From:
Monks Orchard Residents' Association
Planning

8 May 2019
Emails: planning@mo-ra.co
chairman@mo-ra.co
hello@mo-ra.co

Reference:	19/01761/FUL
Application Received:	Fri 12 Apr 2019
Application Validated:	Fri 12 Apr 2019
Address:	Pegasus Fairhaven Avenue Croydon CR0 7RX
Proposal:	Demolition of existing dwelling and erection of a 3-storey block containing 3 x 3-bedroom Houses and 6 x 2-bedroom Apartments with associated access, 9 parking spaces, cycle storage and refuse store.
Consultation Close:	Fri 17 May 2019
Target Date:	Fri 07 Jun 2019
Case Officer:	Nathan Pearce

Figure 2.29e: Requirements for entrances and boundary treatments.

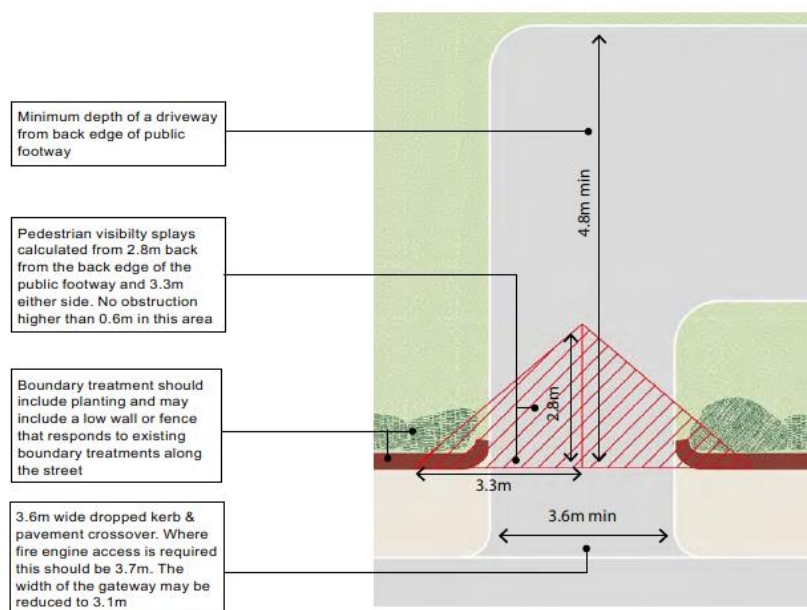
"New driveways should be designed in accordance with Figure 2.29e and 2.29f." (see below). However, this illustration is for a **single dwelling drive** and for drive to a **hardstanding** – NOT an access drive for a small **backland estate development of 9 dwellings**.

This existing width would be acceptable for a single family dwelling's occasional entrance and exit but is **totally unacceptable** for access to a small **backland estate development** accommodating **33 occupants** and **9 cars** and to provide access for the various delivery vehicles to the **9 dwellings**, lorries for building construction and materials and removal Pantechicons for furniture and white goods delivery when new occupants move in to the new dwellings. The Drive Access width as required by **SPD2 Section 2.29** is **3.6m minimum** with a **3.3m visibility splay** from the centre of the drive to either side for safety of pedestrians (See fig 29e). The adjacent wall RHS view toward the drive is greater than 0.6m. This proposal with drive width of **2.83m** does **NOT** meet this SPD2 requirement and **should therefore be refused**.

Illustrations of the 45° Rule regarding the adjacent property

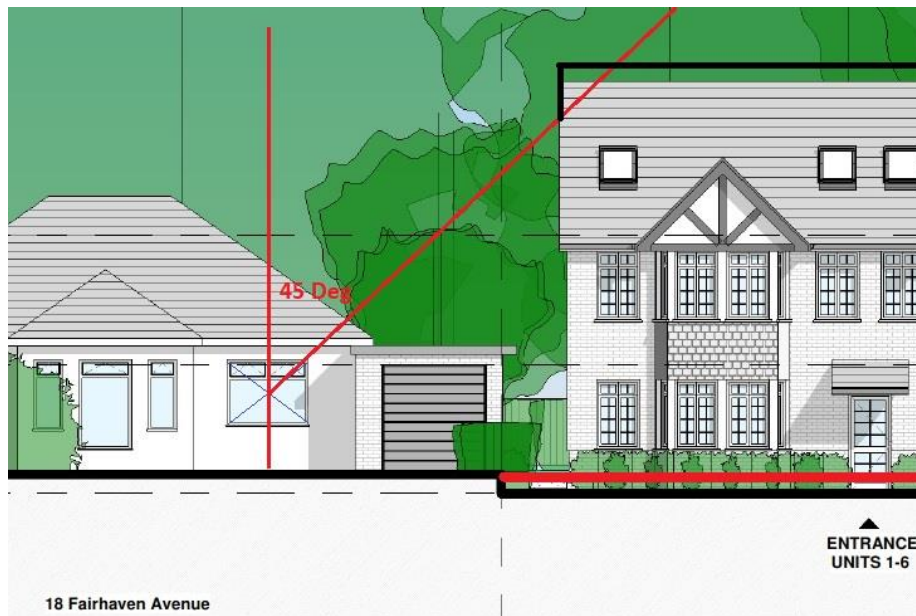
This illustrates that the proposed development **fails to meet this 45° rule on height and will intercept the 45° projection** in relation to the **adjacent property**. It should be recognised that the proposed development is to be **sunk into a ≈0.5m hole in the ground** in order to meet the surrounding properties height restriction. **If the built form is NOT actually sunk into the ground**, the built form would be **≈0.5m higher** and the projected **45° Rule** would show much more of the proposed development would be **above the 45° intercept projection** and significantly greater **non-compliance** to the policy. **The built height is therefore extremely critical.**

Waste and Recycling in Planning Policy Document August 2015 Edited October 2018 - Produced by **LBC Waste Management Team - Section 4 Flats with 5 or more units.**

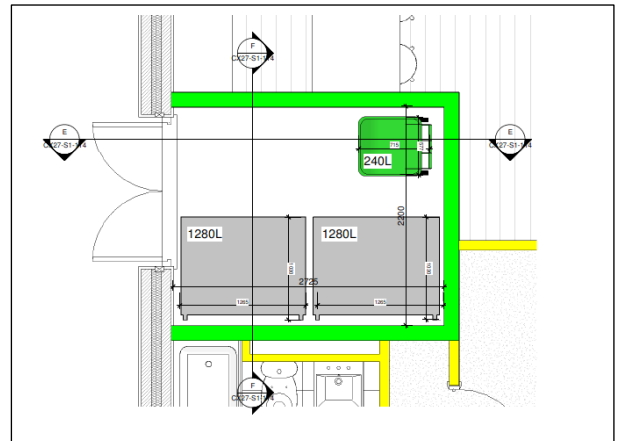
None are provided for the House Units. The House Units have no refuse or recycling storage facilities so will need to use the communal Refuse and Recycling Store but we believe the communal Refuse and Recycling Storage is inadequate for the proposed total of 9 dwellings and 33 occupants if it also includes those within the three House Units. The distance from House Unit 1 to the Communal Refuse Storage is approximately **35metres** which is an unacceptable distance to carry refuse. An occupier should not be required to carry waste a distance of more than **30 m.** (British Standards BS 5906:2005 Para 7.2.2). *“Waste storage chambers, detached or as part of the building, should be sited **within 30 m** (excluding any vertical distance) from each dwelling.”*

The pull route to the Refuse Vehicle is only **1m wide** (inappropriate) which is insufficient for the **1280L Refuse Bins** to be maneuvered along the length of the pathway and the surface of the pathway is intermittent paving slabs which, over time will become uneven and bumpy, allowing the bin wheels to foul the paving slabs or sink into the gaps between the slabs. This passageway solution is not wide enough to physically allow removal of the 1280L capacity Refuse Bins or conducive to long term use and should be avoided.

The Waste and Recycling in Planning Policy Document at **Para 4.6** states: All doors and alleys must be at least **2m** wide to allow for safe maneuvering of bins. Doors must not open outward over a public footway or road, and should not cause an obstruction to other access when in an open position. They should be able to remain or be secured in the open position so that access for collection staff is unimpeded when the bins are being emptied. The proposal does not meet these requirements.

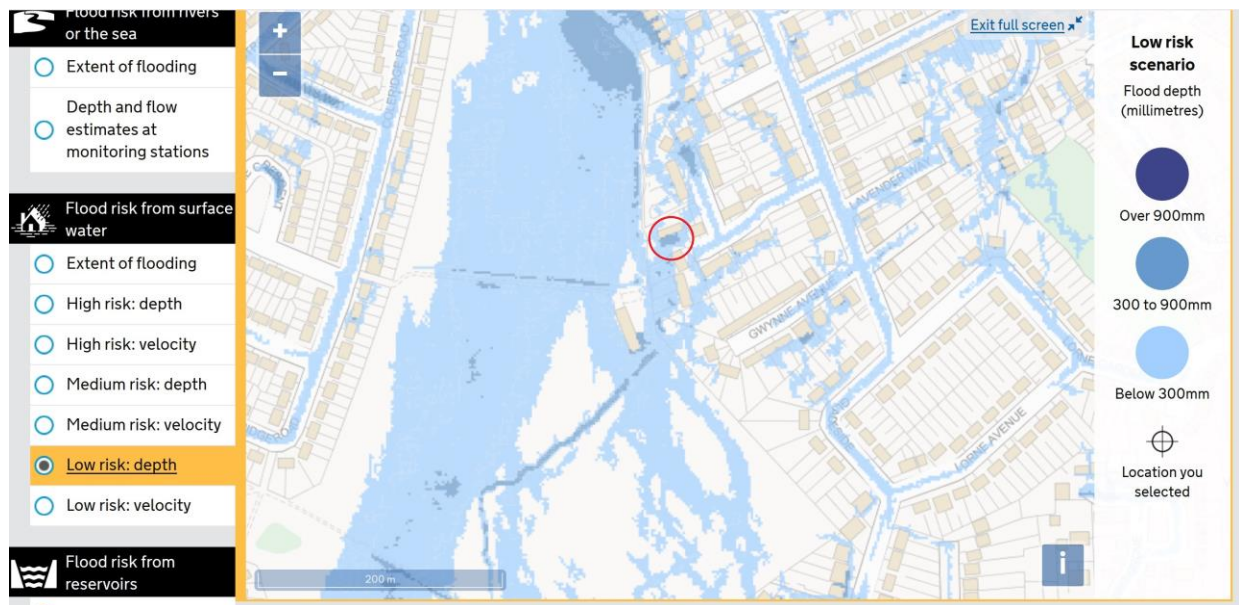
The proposed development is in a low risk flood area which has a possible **300mm to 900 mm** flood depth as indicated in the above Environment Agency Flood Map (Circled) exacerbated by the proposed development being sunk into a **≈0.5 metre hole in the ground**.

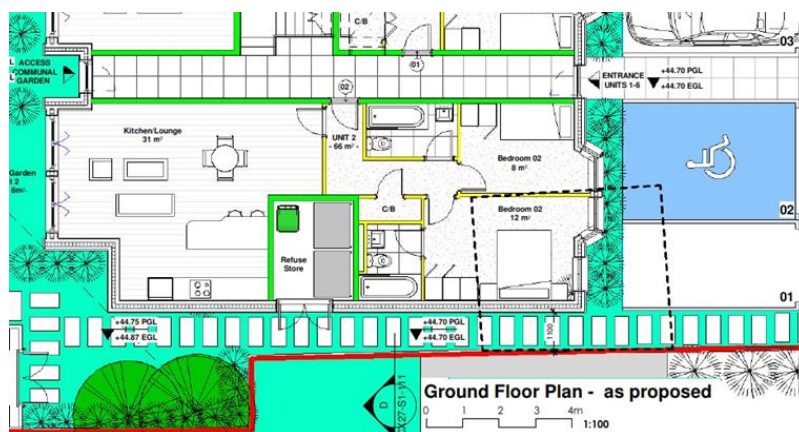
The Croydon Local Plan for **Residential Parking** is more stringent than the **London Plan Policies** in that the Policy is as per **London Plan Table 6.2** however, there is no provision for higher levels of car parking in areas with low Public Transport Accessibility Levels, which ignores the reasoning for additional parking provision to alleviate overspill on-street parking at low PTAL locations.

This location is a typical reason why it is appropriate to meet the London Plan higher provision due to this locality's amount of local on-street parking and the fact that the local road is a cul-de-sac of only **5metres** width and cannot cope with additional on-street parking which reduces the available road width to other road users and clogs the turning head.
